**Beaver Dam Mine Project Environmental Impact Assessment
 Information Request Responses, Round 2**

Round 2 Information Request Number:	NSE-2-02
Regulatory Agency/Indigenous Community:	NSE-Lands and Forestry–Regional Services
Topic/Discipline:	Wetlands
EIS Guideline Reference:	Not listed
Revised EIS (February 28, 2019) Reference:	Not listed

FIGURE NSE-2-11-1

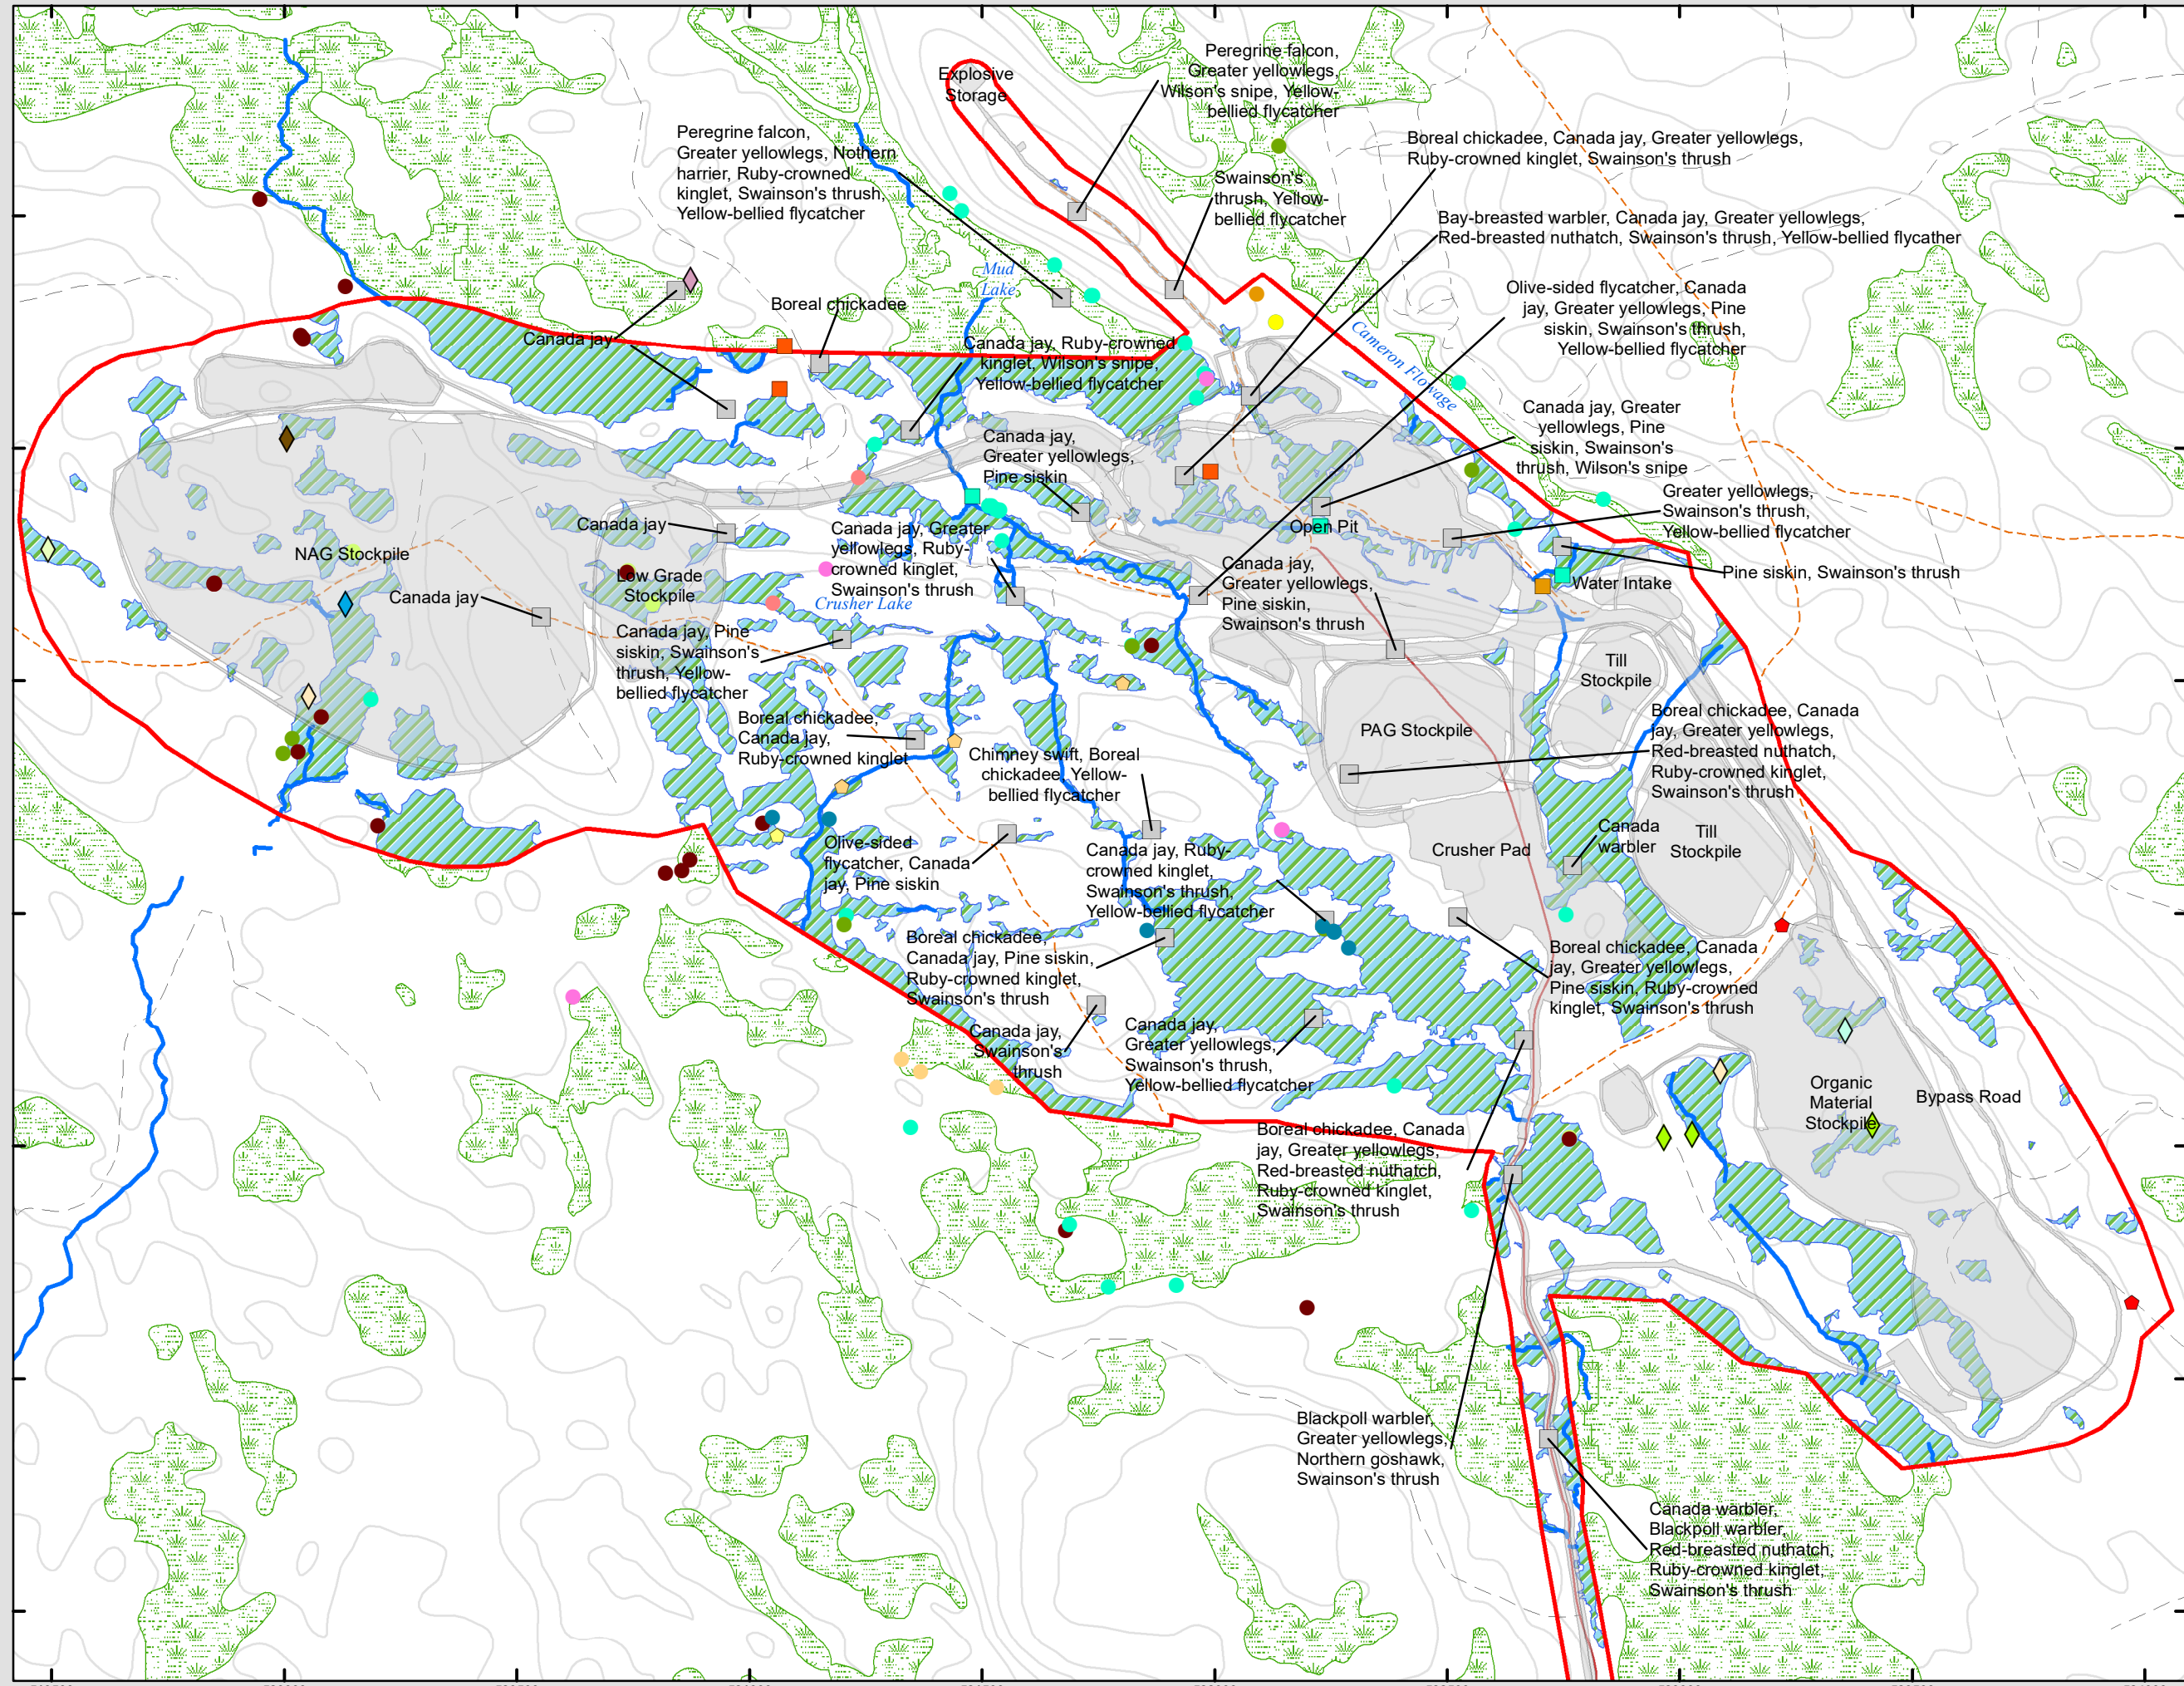
Round 2 Information Request Number:	NSE-2-11
Regulatory Agency/Indigenous Community:	NSE-Lands and Forestry–Regional Services
Topic/Discipline:	Habitat and Flora
EIS Guideline Reference:	Not listed
Revised EIS (February 28, 2019) Reference:	Figure 6.10-2 – Priority Species

Section 6.10.4.2, Figure 6.10-2, page 6-580 illustrates priority species observations only and does not include all avifauna observed at each observation location. Where there is an observation location (box) without a species, no priority species was observed at this location.

This figure has been revised for the Updated 2021 EIS (AMNS 2021) and included here as Figure NSE-2-11-1. Avifauna observation locations without priority species observations have been removed from the priority species figures. All avifauna observation locations are shown on a separate figure.

One *Chelydra serpentina* observation was made at the Beaver Dam Mine Site. This has been shown on Figure NSE-2-11-1.

FIGURE NSE-2-12-1

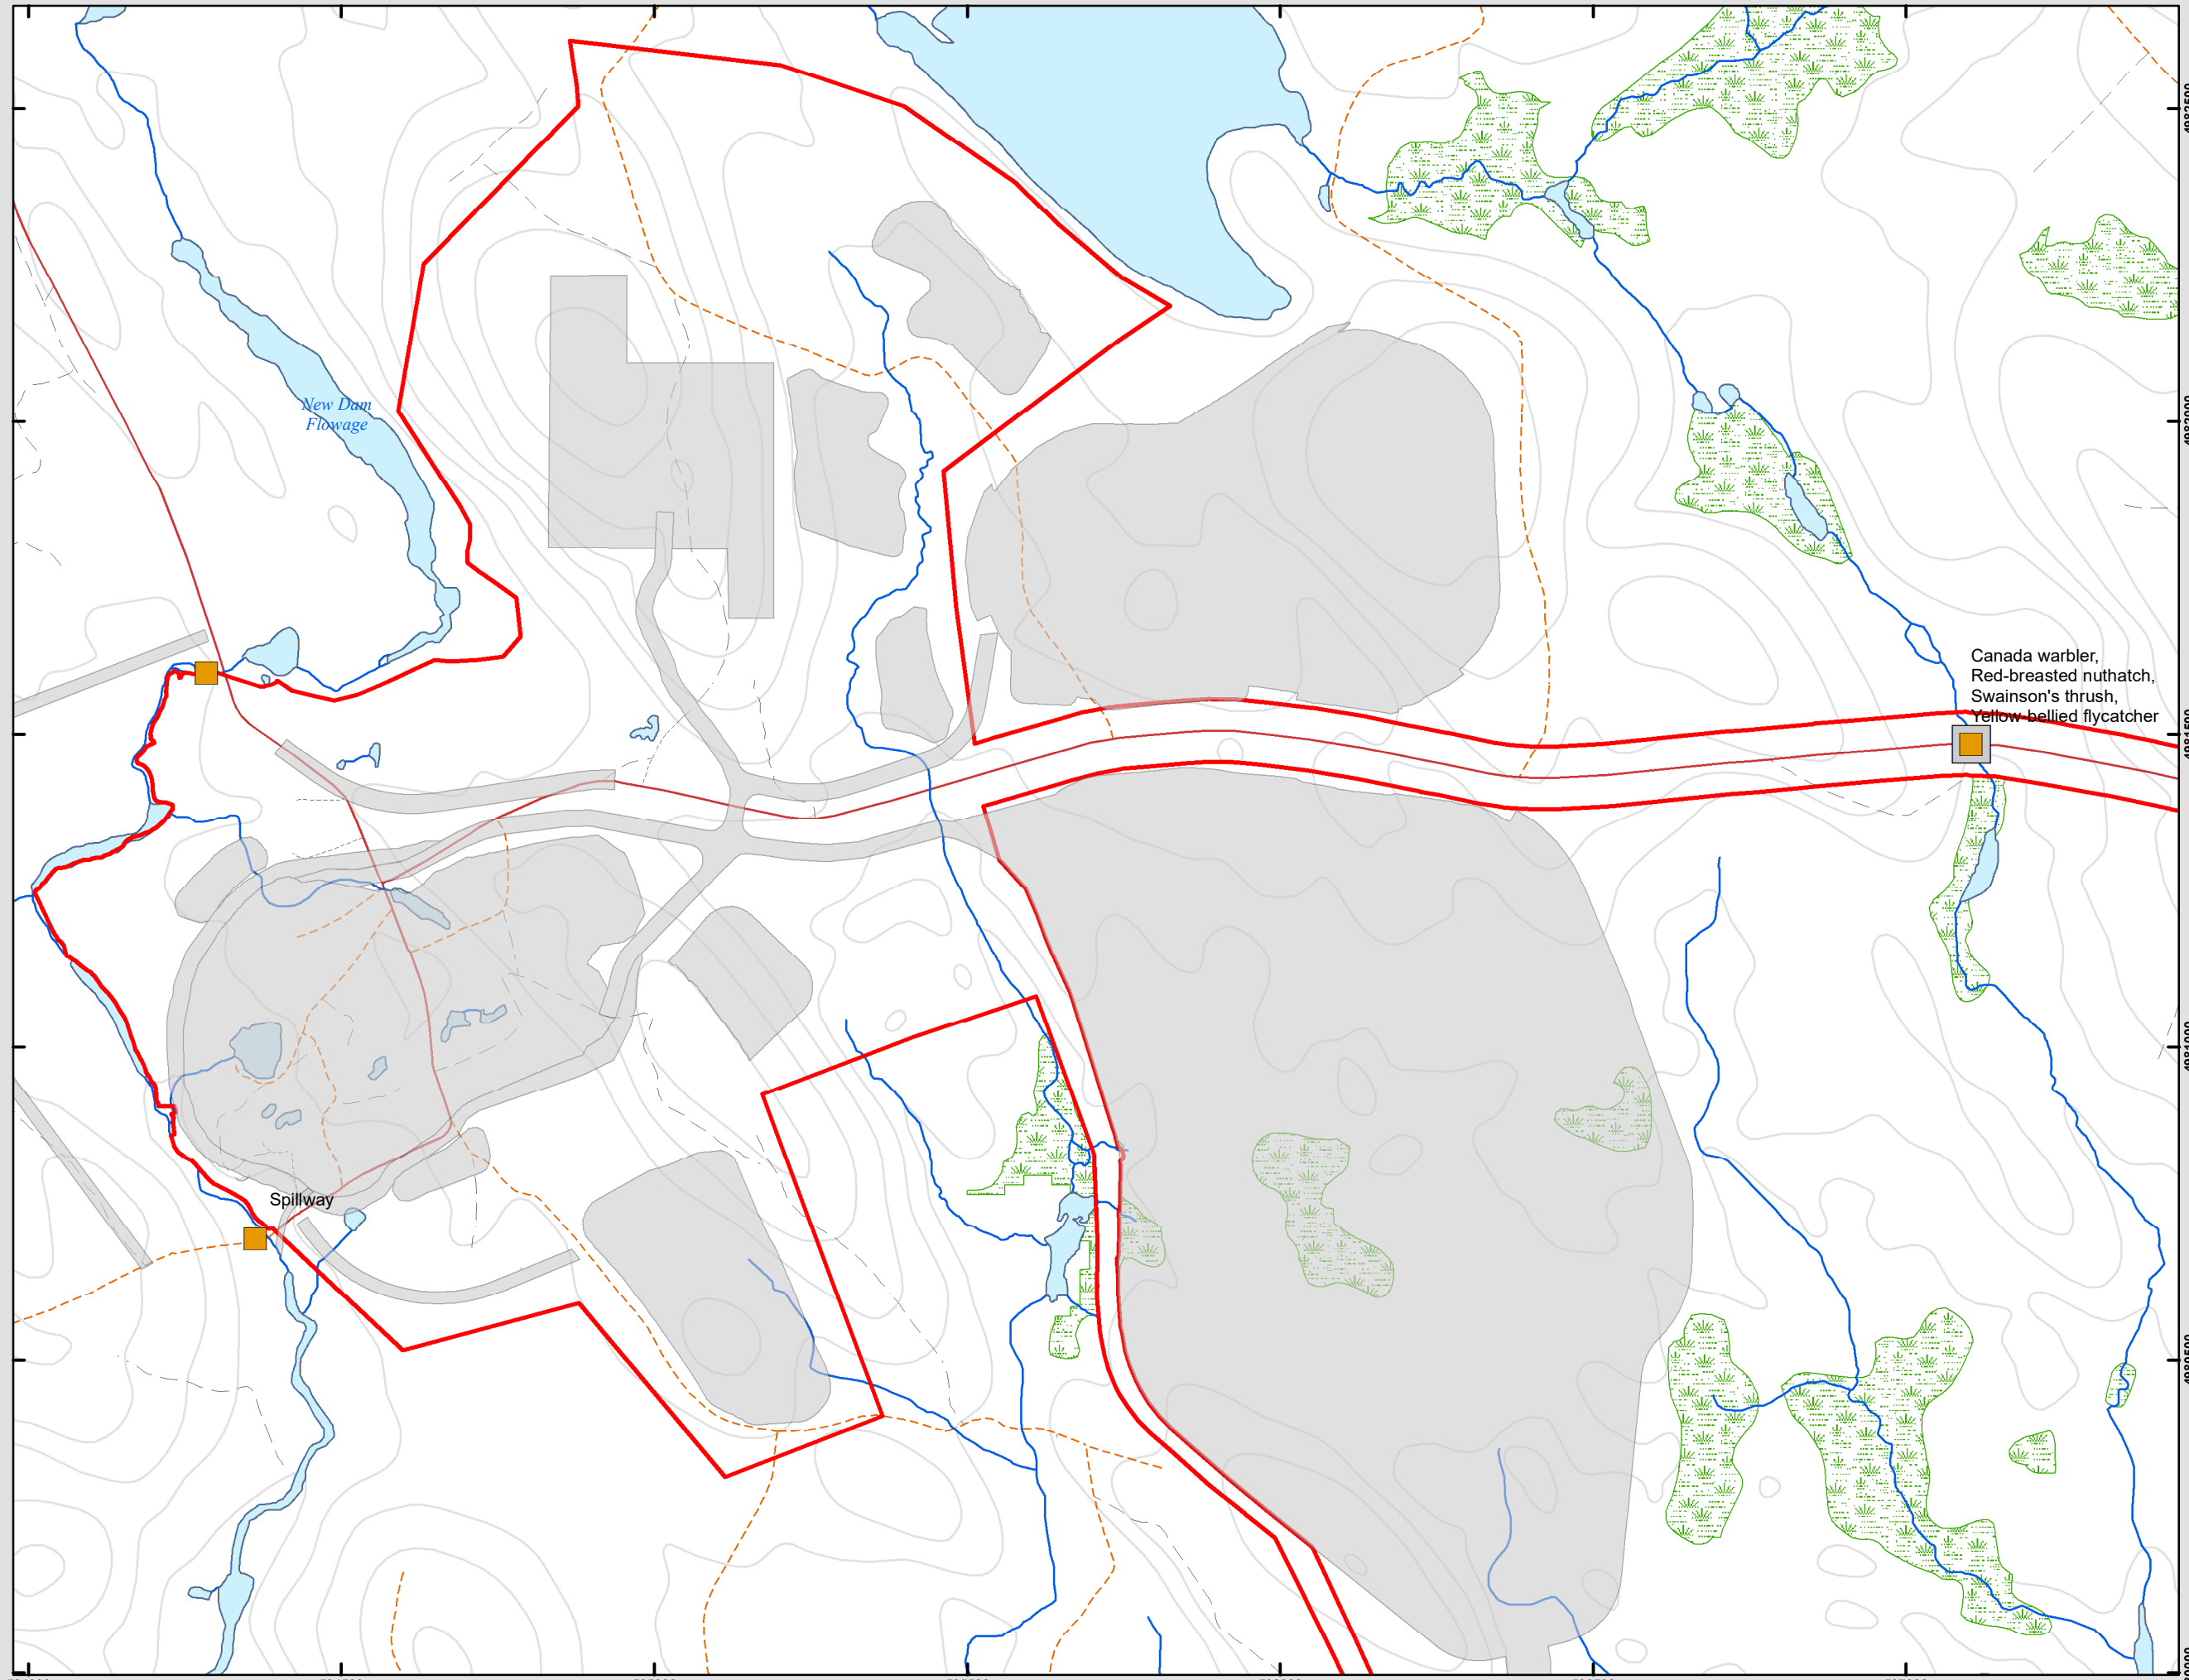
Round 2 Information Request Number:	NSE-2-12
Regulatory Agency/Indigenous Community:	NSE-Lands and Forestry–Regional Services
Topic/Discipline:	Habitat and Flora
EIS Guideline Reference:	Not listed
Revised EIS (February 28, 2019) Reference:	Figure 6.10-2 L– Priority Species

This figure has been revised for the Updated 2021 EIS (AMNS 2021) and included here as Figure NSE-2-12-1. All observations, including *Chelydra serpentina*, have been more clearly symbolized.
